Manitowoc® Service Communicator

Subject: Q130/Q210 Ice Machines

Compressor Relay Replacement

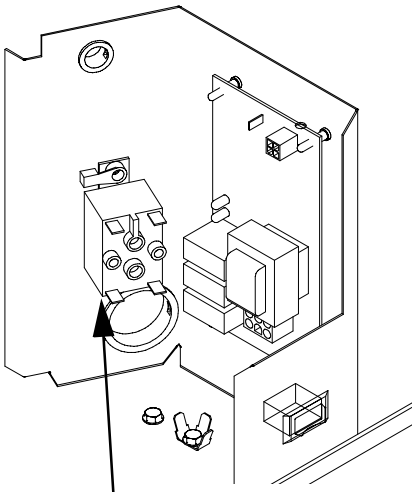
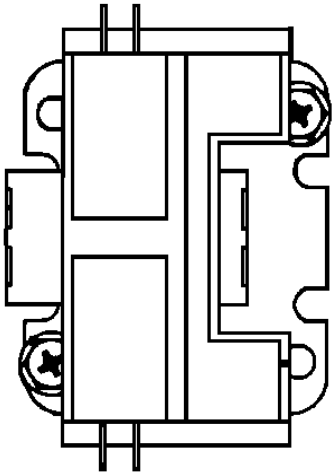
The Q130/Q210 compressor relay has been replaced with a contactor. Compressor failure can result if the compressor runs for extended periods under no load conditions (water pump off). If you have experienced a compressor failure, verify the relay contacts open and close correctly. Initiate an Automatic Shut-Off Sequence by opening the bin switch for more than 7 seconds during the harvest cycle (Q130 hold ice damper down - Q210 hold water curtain open). The compressor de-energizes when the automatic shut-off cycle begins.

Kit number 7600833 (115/60/1) or 7600843 (208-230/50-60/1) are used for field replacement on all Q130/Q210 ice machines manufacturered with a relay.

- Replacing the relay with a contactor
- Replacing the contactor mounting screws
- Replacing the control box cover
